MONITORING YEAR 2 ANNUAL REPORT

DEEP MEADOW MITIGATION SITE

Re: Draft - Monitoring Year 2 Report for the
Deep Meadow Mitigation Site
Yadkin River Basin – CU 03040105– Yadkin County
DMS Project # 97131
Contract # 006887

Figure 3.0 Current Condition Plan View (Key)
 Deep Meadow Mitigation Site
 DMS Project No. 97131
 Monitoring Year 2 - 2021
 Union County, NC

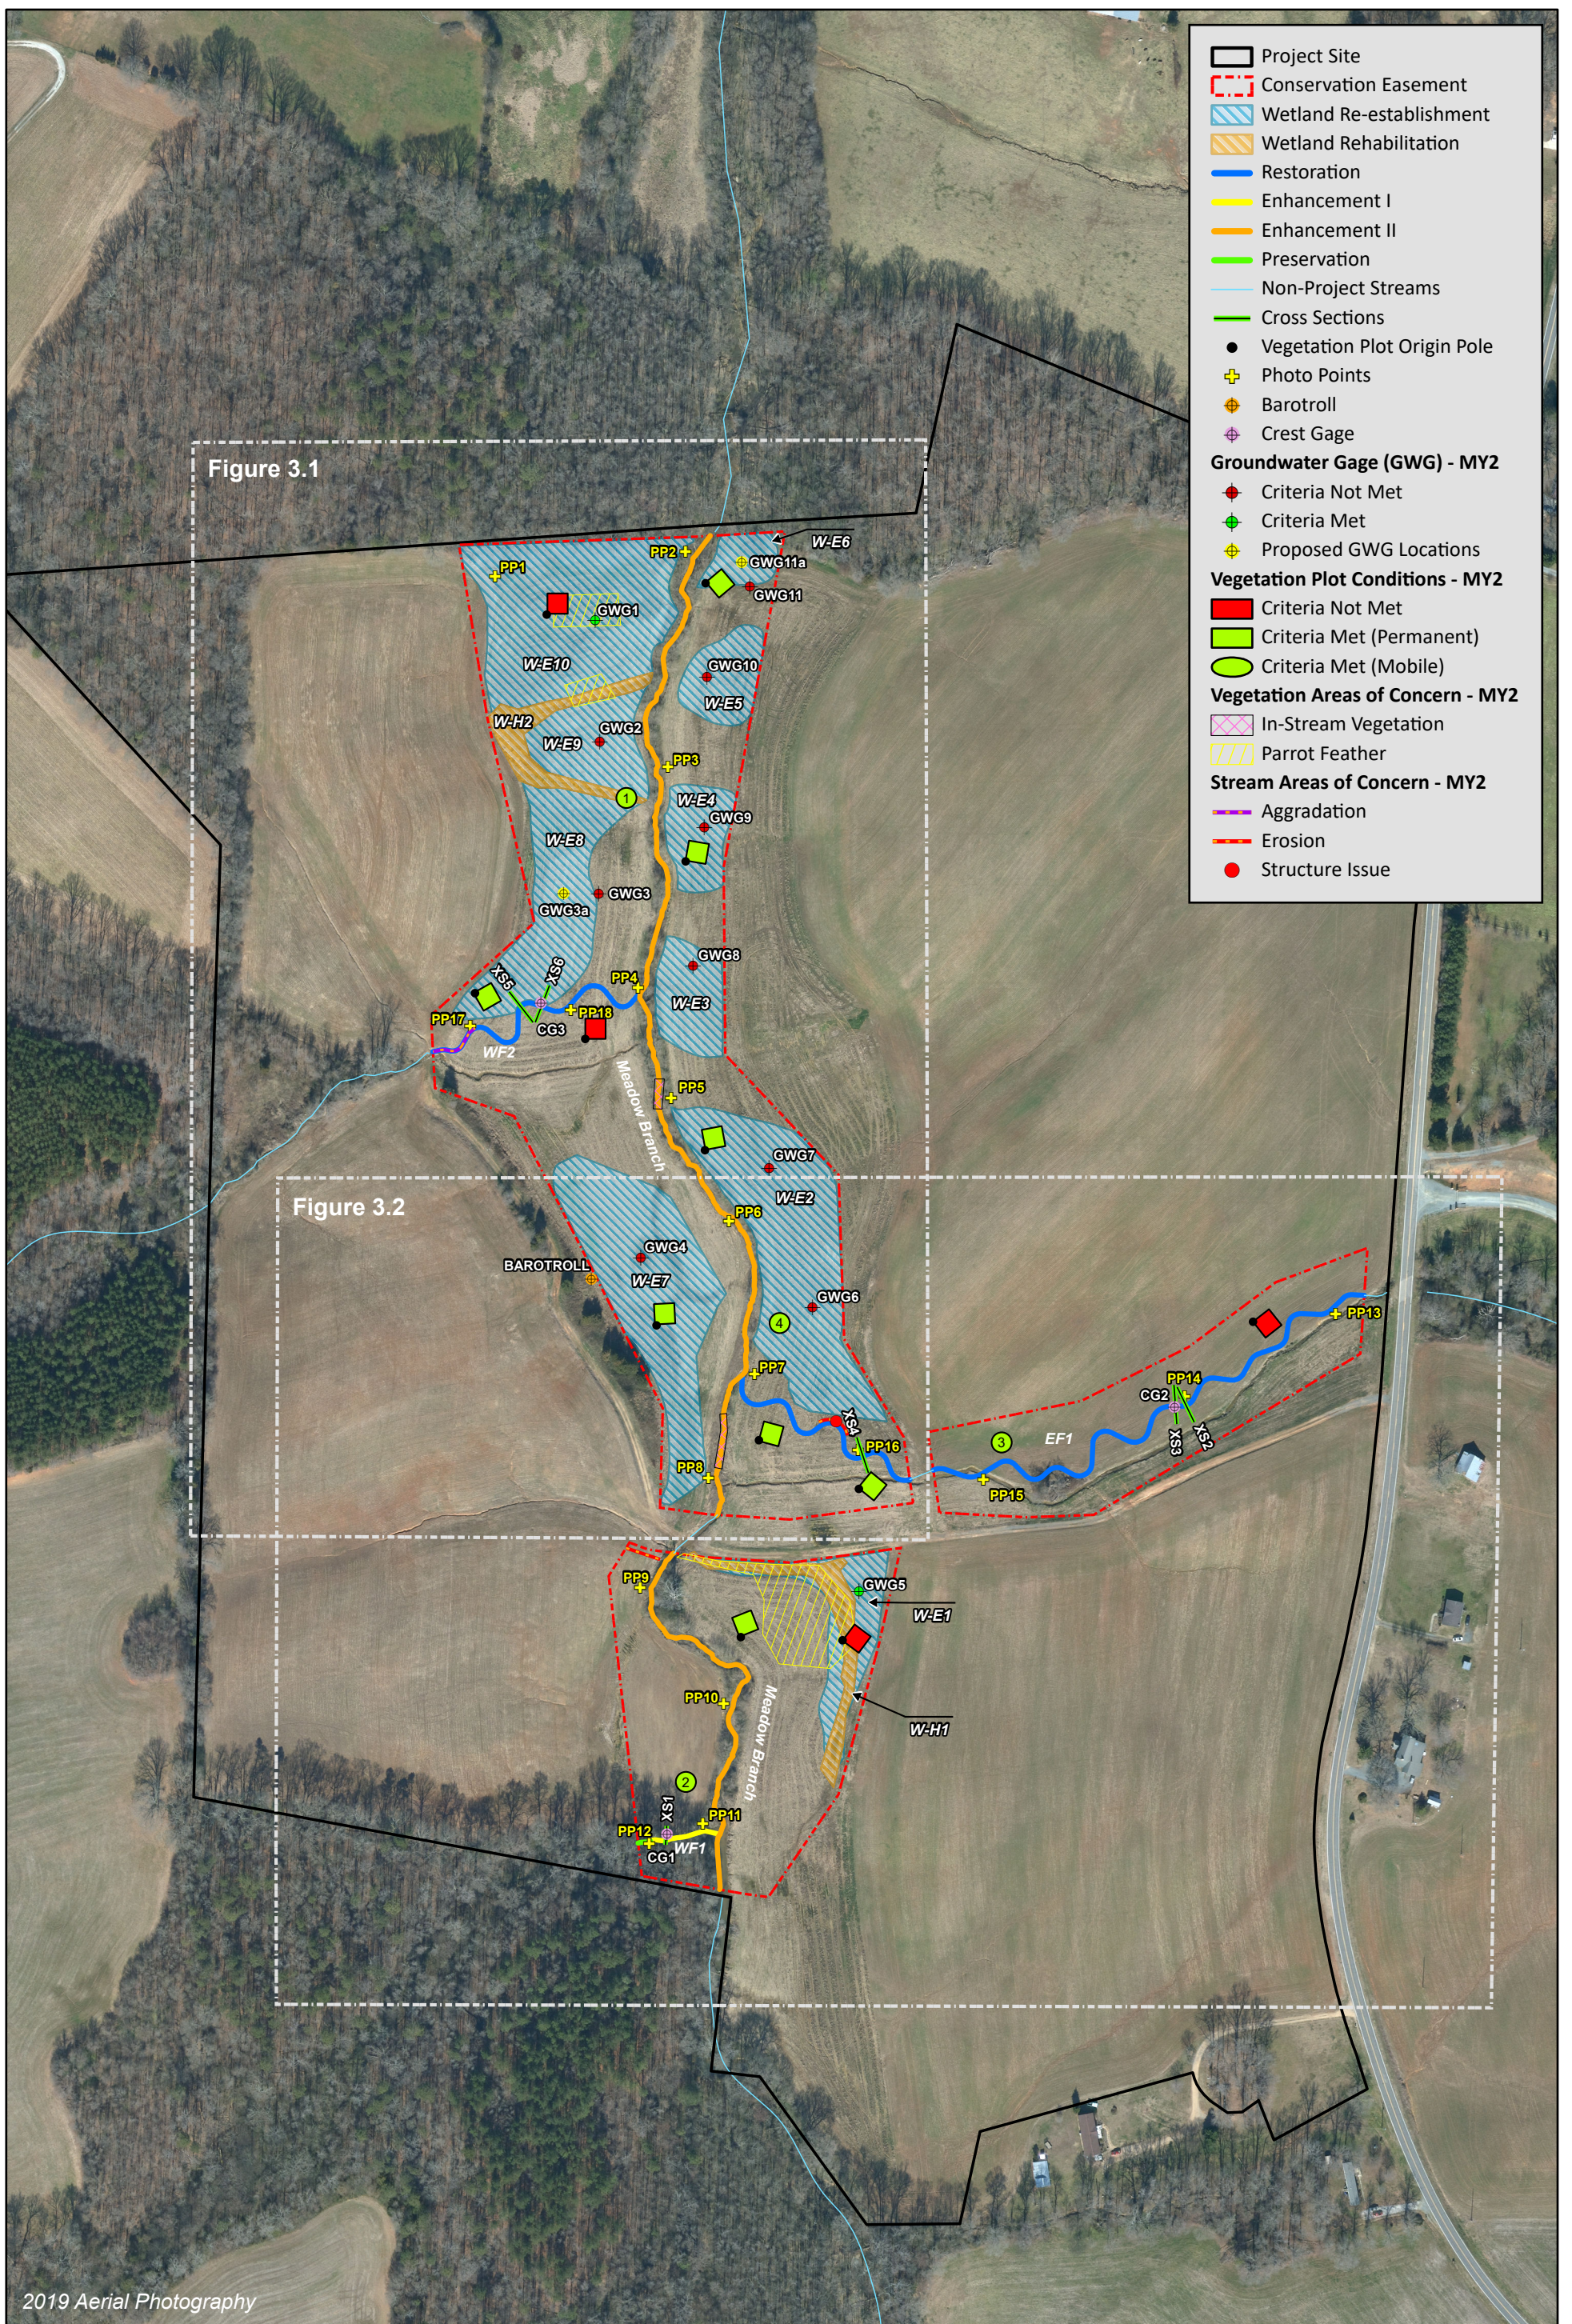
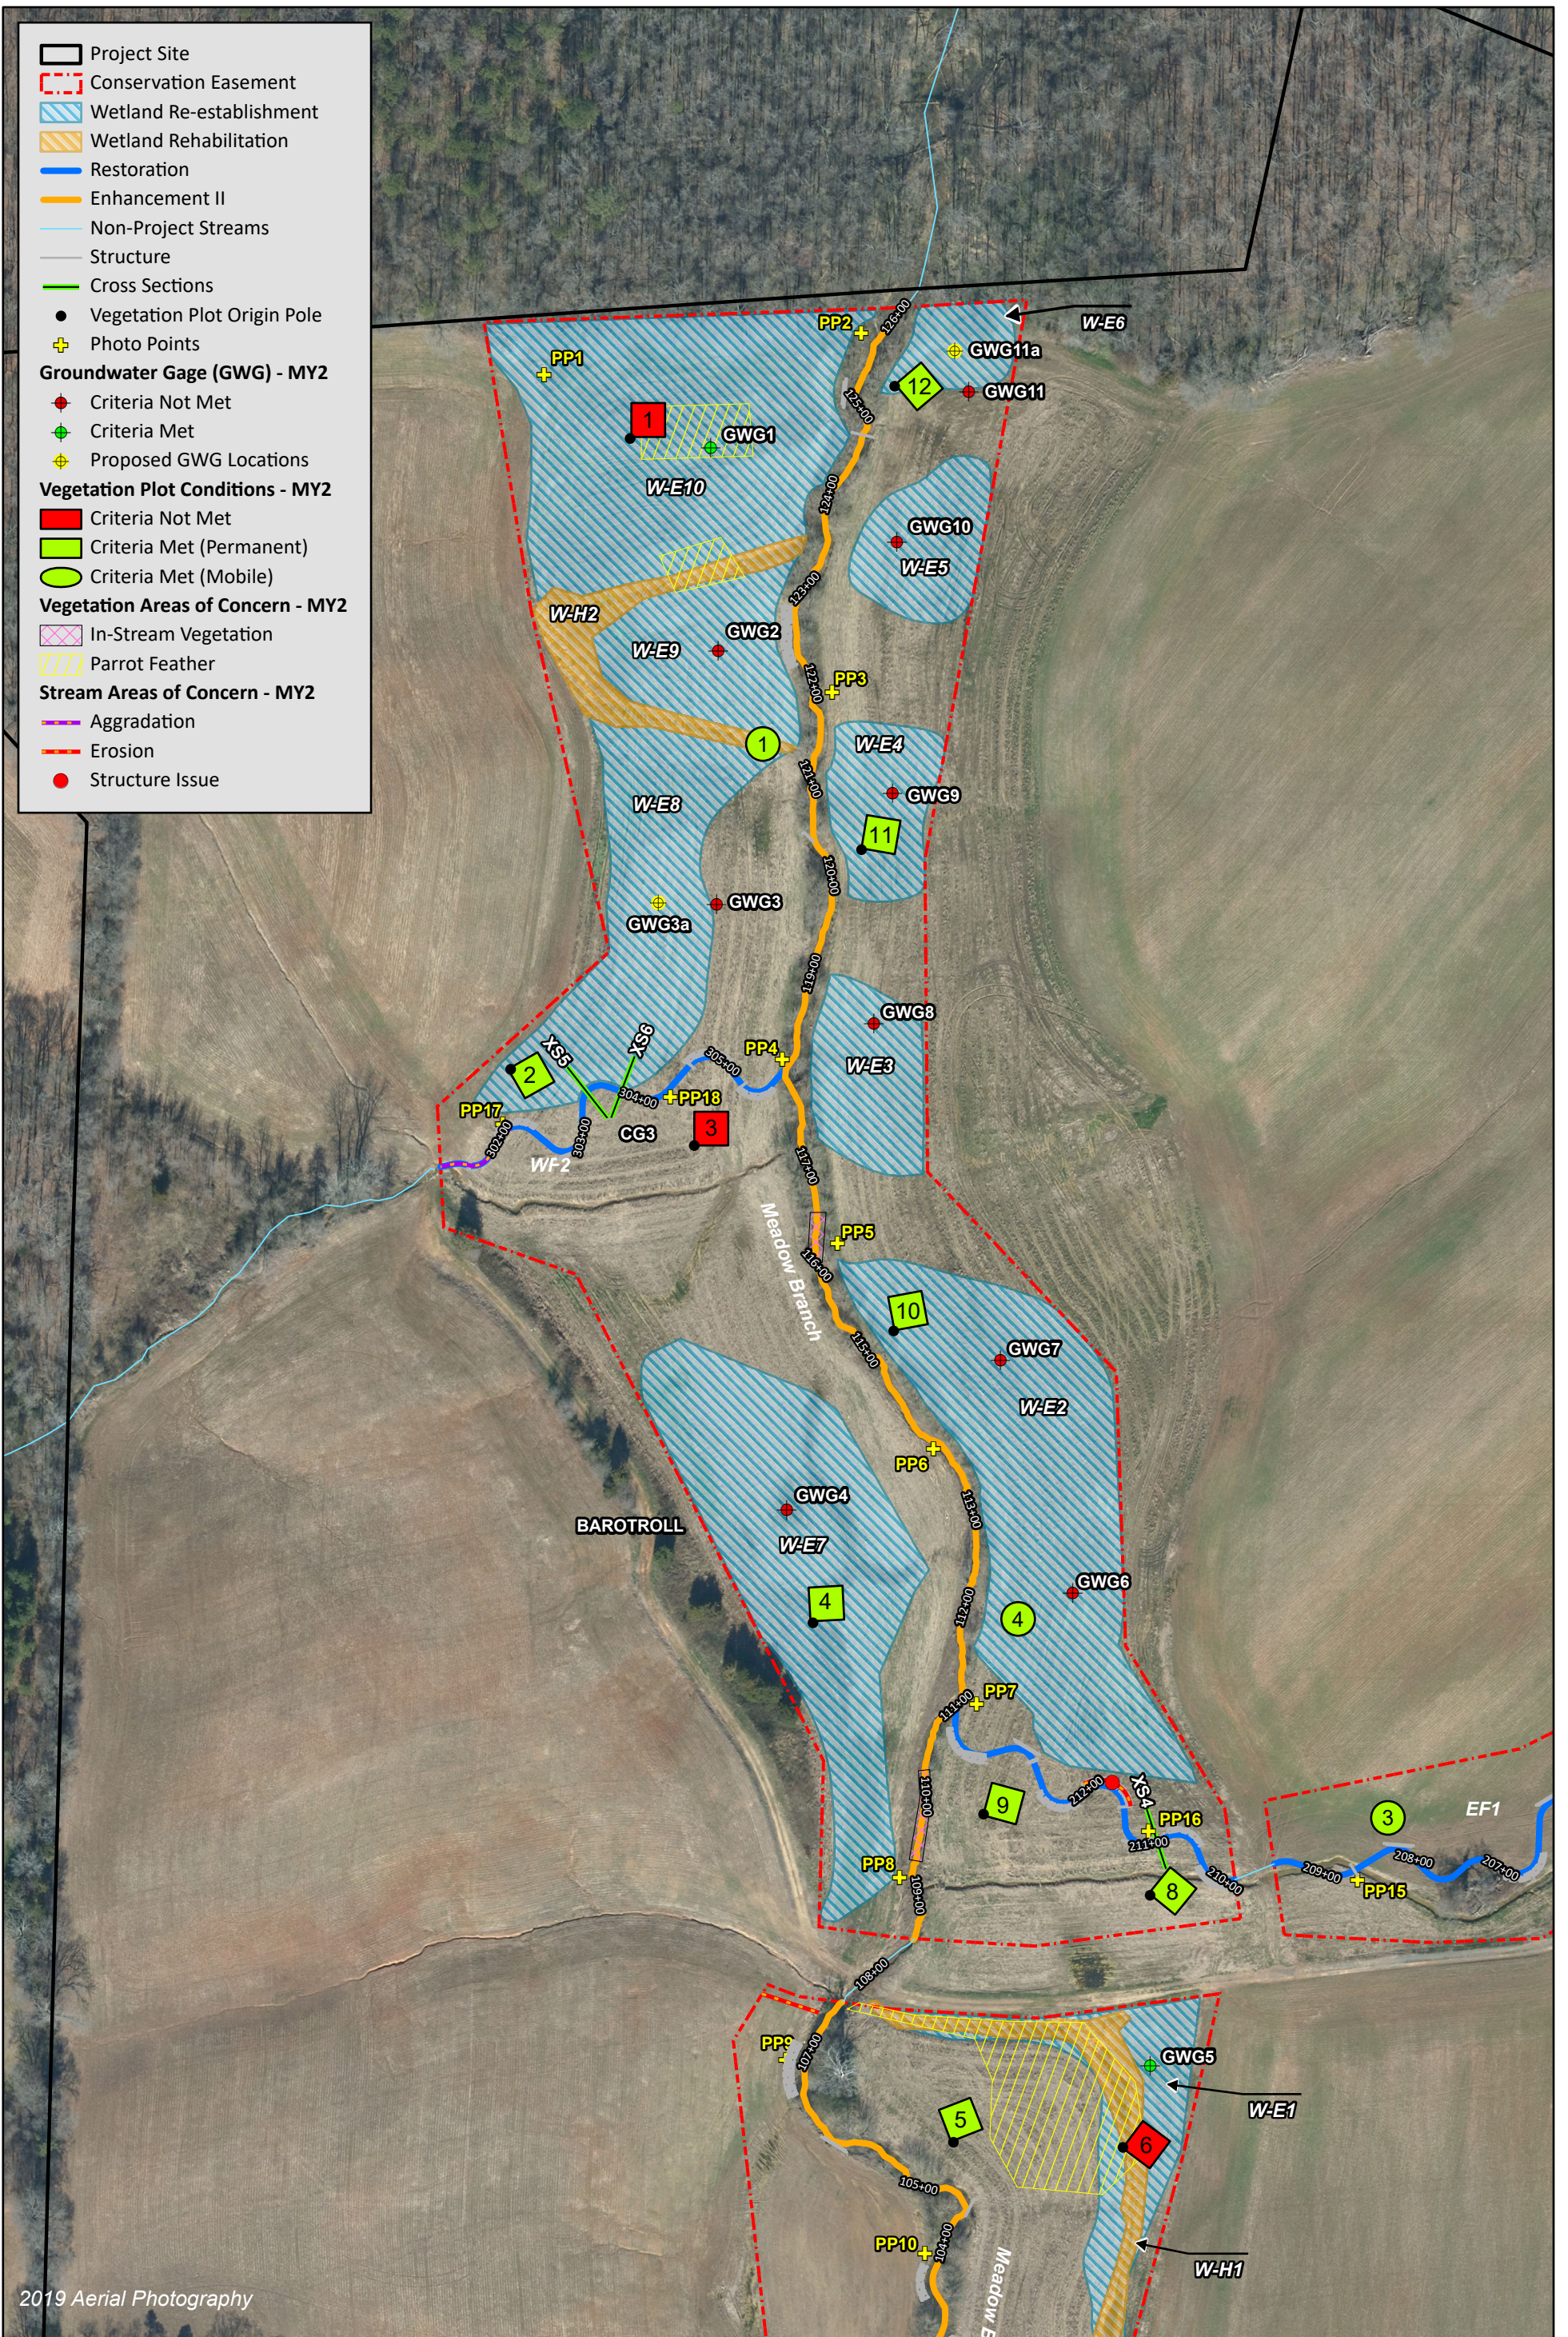
DMS' Comment: Section 1.4.6 Wetland Assessment: With the gage success rate being less than ideal, Wildlands has indicated intent to add two gages to the project in response to performance issues over the first two years at GWGs 3 and 11.

- 1) It is assumed that Wildlands will continue to monitor these two wells, correct? If not, please indicate.**
- 2) Please map the locations of the two new wells, or if not yet known, estimate where they will be installed on the map.**

DMS' Comment: Figures 3.0 - 3.2: There a "bankfull" line on the CCPVs (thick black dashed line), it is recommended removing this unless it serves a specific monitoring function on the maps.

Wildlands' Response: Wildlands' will continue to monitor all groundwater wells, as well as newly installed groundwater wells until project closeout. Proposed well locations have been added to Figures 3.0 - 3.2.

Wildlands' Response: Wildlands removed the bankfull line on Figures 3.0 - 3.2.
